CITY OF VINELAND

**RE: Street Lighting Recommendations  
September 2017**

## STREET LIGHTING RECOMMENDATIONS

SEPTEMBER 2017

<b>PROPOSED STREET LIGHT REVISION</b> AREA OF WEST BLVD BETWEEN BUTLER BLVD AND SW BLVD	
<b>VINELAND MUNICIPAL ELECTRIC UTILITY</b> <b>VINELAND, NEW JERSEY</b>	
DRAWN: CAM	VAULT # F-3-C
DATE: 8/11/2017	DRAWING # VMEU-2844
SCALE: NTS	CHECKED:

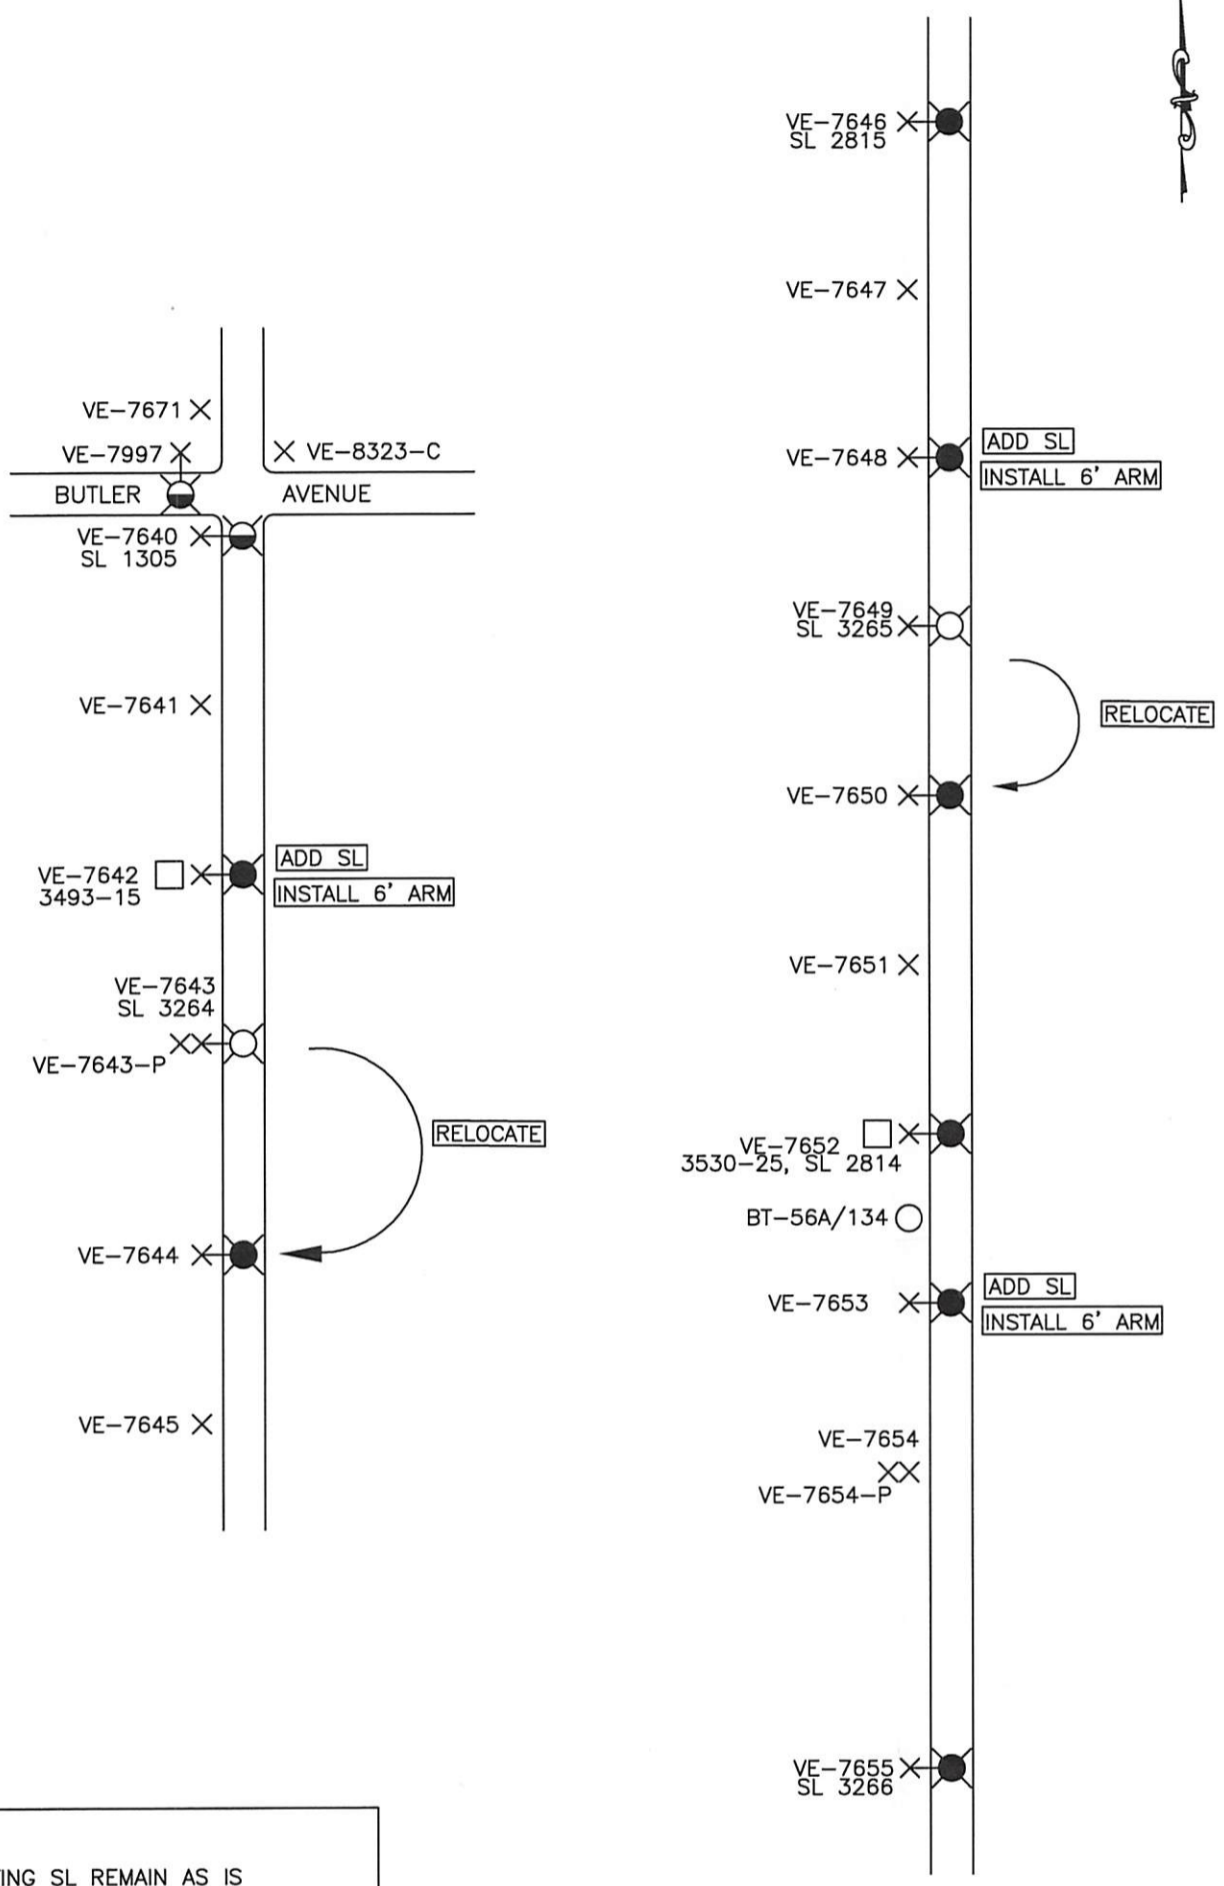
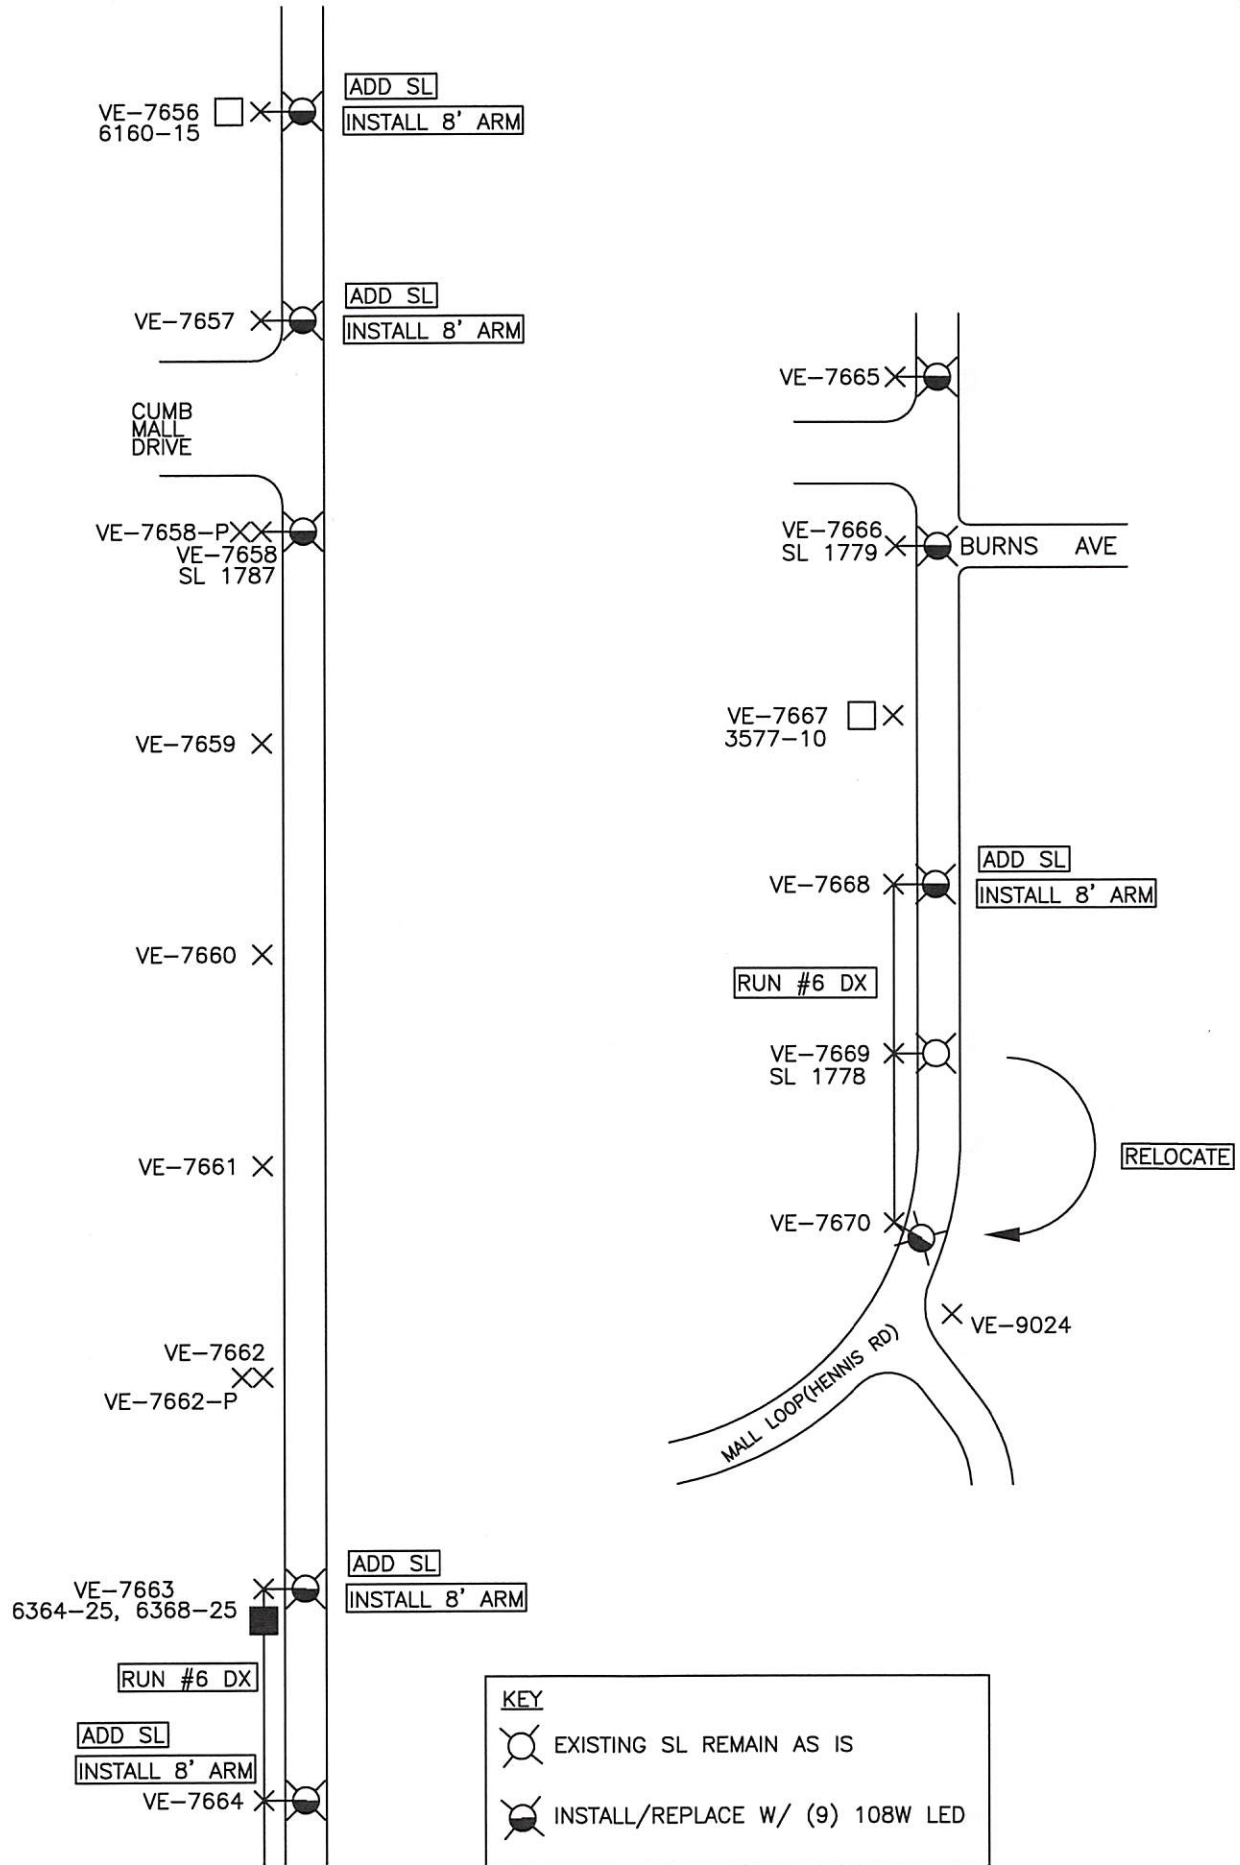
6. Area of West Boulevard  
*(between Butler Ave & SW Blvd)*  
Drawing No. VMEU-2844  
Upgrade five (5) existing street lights to 74W LED (relocating five), six (6) to 108W LED. Install an additional three (3) 74W LED, and five (5) 108W LED street lights onto existing utility poles.

**PROPOSED:** Upgrade five (5) existing street light to 74W LED (relocating five), six (6) to 108W LED. Install an additional three (3) 74W LED, and five (5) 108W LED st. lts. onto existing utility poles.

<b>PROPOSED STREET LIGHT REVISION</b> AREA OF SOUTH PEAR ST BETWEEN FOURTH ST AND WEST BLVD	
<b>VINELAND MUNICIPAL ELECTRIC UTILITY</b> <b>VINELAND, NEW JERSEY</b>	
DRAWN: CAM	VAULT # F-3-C
DATE: 8/16/2017	DRAWING # VMEU-2845
SCALE: NTS	CHECKED:

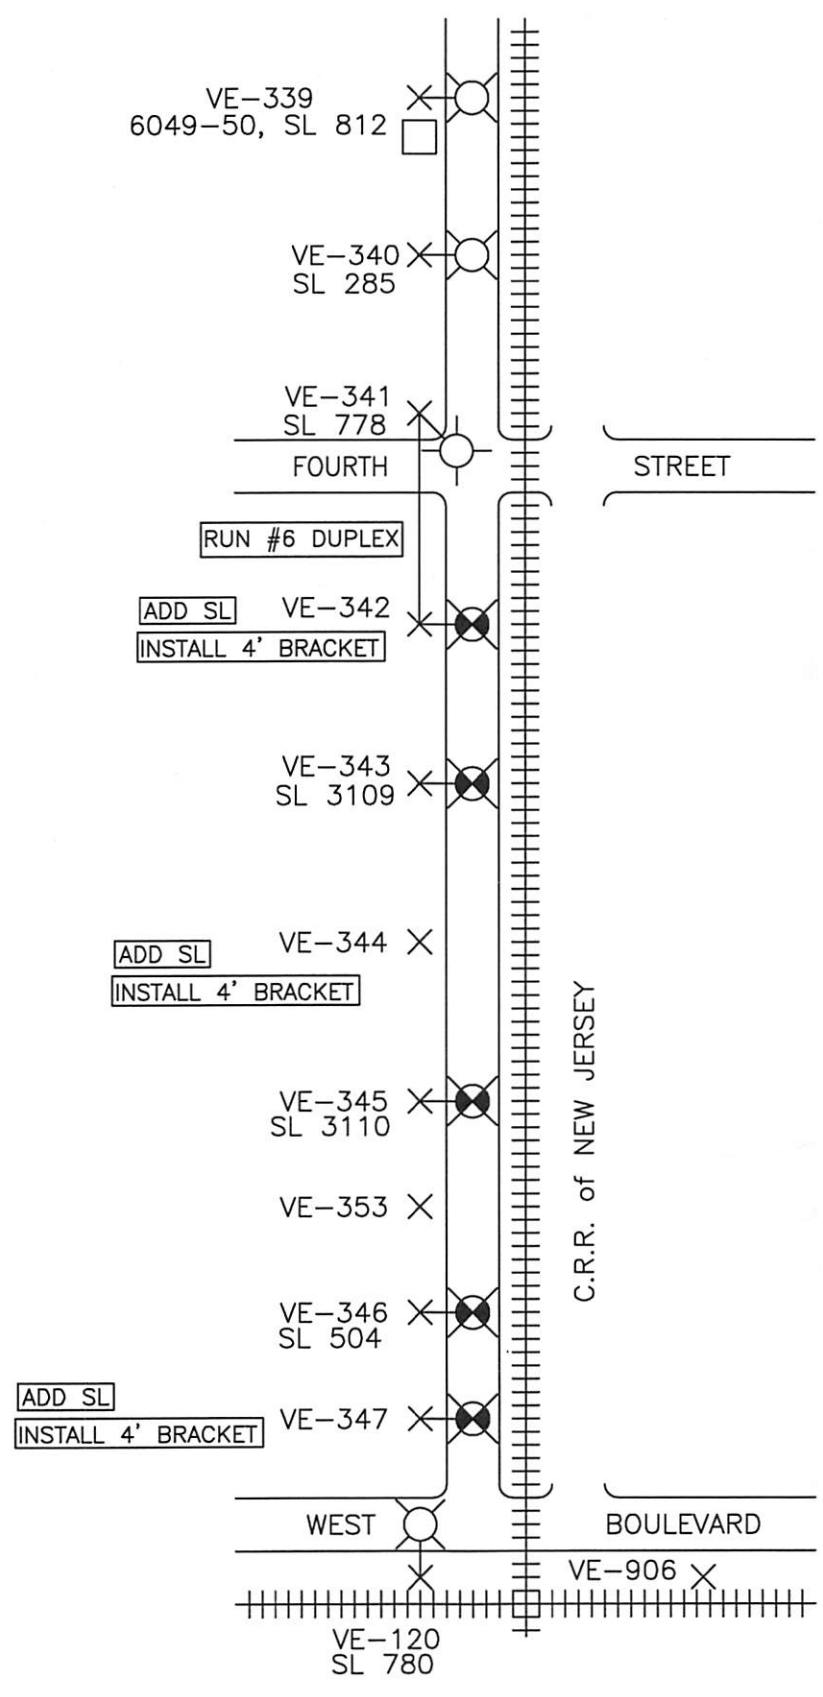
7. Area of South Pear Street  
*(between Fourth St & West Blvd)*  
Drawing No. VMEU-2845  
Upgrade three (3) existing street lights to 54W LED. Install an additional three (3) 54W LED street lights onto existing utility poles.

**PROPOSED:** Upgrade three (3) existing street lights to 54W LED. Install an additional three (3) 54W LED st. lts. onto existing utility poles. Per police department request.

*\* Requested by VPD - Street Crimes Unit*

**PROPOSED STREET LIGHT REVISION**  
**AREA OF NORTH PEAR ST BETWEEN SECOND ST AND FOURTH ST**

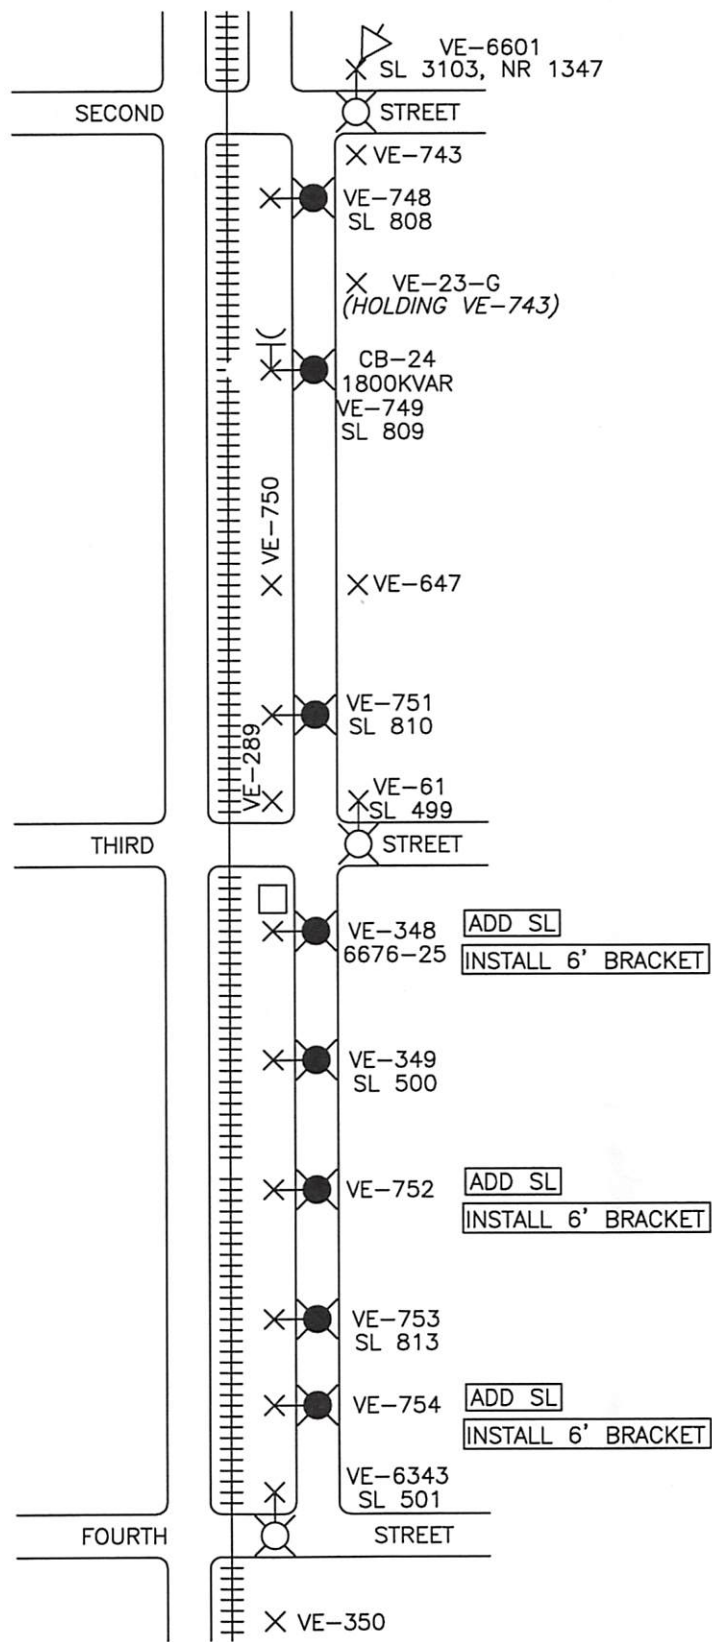
8. Area of North Pear Street  
*(between Second St & Fourth St)*  
Drawing No. VMEU-2846  
Upgrade five (5) existing street lights to 74W LED. Install an additional three (3) 74W LED street lights onto existing utility poles.

**PROPOSED:** Upgrade five (5) existing street lights to 74W LED. Install an additional three (3) 74W LED st. lts. onto existing utility poles. Per police department request.

*\* Requested by VPD - Street Crimes Unit*
